# 2018 Annual Inspection Report

Gavin Power, LLC

## Residual Waste Landfill

Gavin Power Plant  
Cheshire, Ohio

**Pond No. 1**

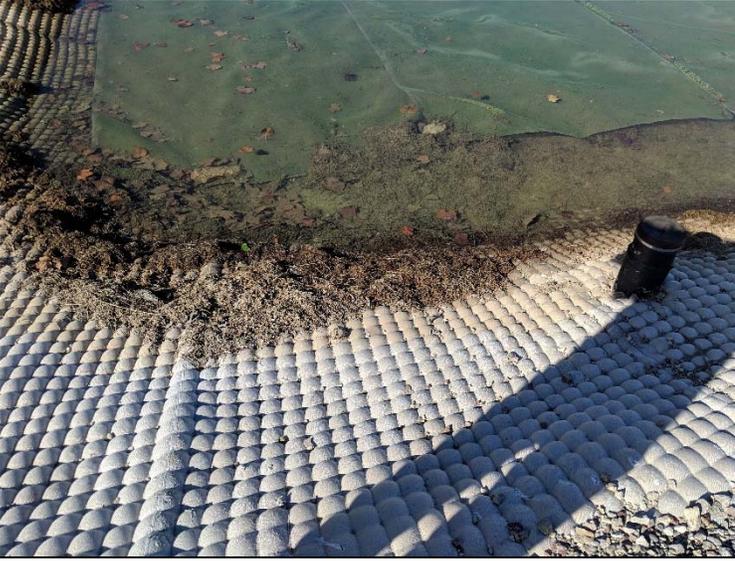
Pond 1 appeared to be functioning properly during ERM's visit. An active dewatering bag observed during the inspection is shown on Photograph 34. The bag appeared to be functioning satisfactorily at the time of inspection and was discharging relatively clear effluent. A buildup of sediments and vegetation was observed at the inflow to Pond 1. For maintenance purposes these materials should be removed and properly disposed. A small tear was observed in the liner of the clarifying pond on the southern corner. ERM recommends that this tear be repaired as part of routine maintenance.

8. Remove excessive vegetation growth from inside Ponds 1 and 3 and continue maintenance on other ponds. Clean channel inlets on both Ponds 1 and 3 to removed sediment buildup.

9. The small tear of the clarifying pond liner at Pond 1 should be repaired as part of routine maintenance operations.
10. Gravel material observed on the west side of Pond 2 should be removed and Pond 2 should be repaired as part of routine maintenance operations.
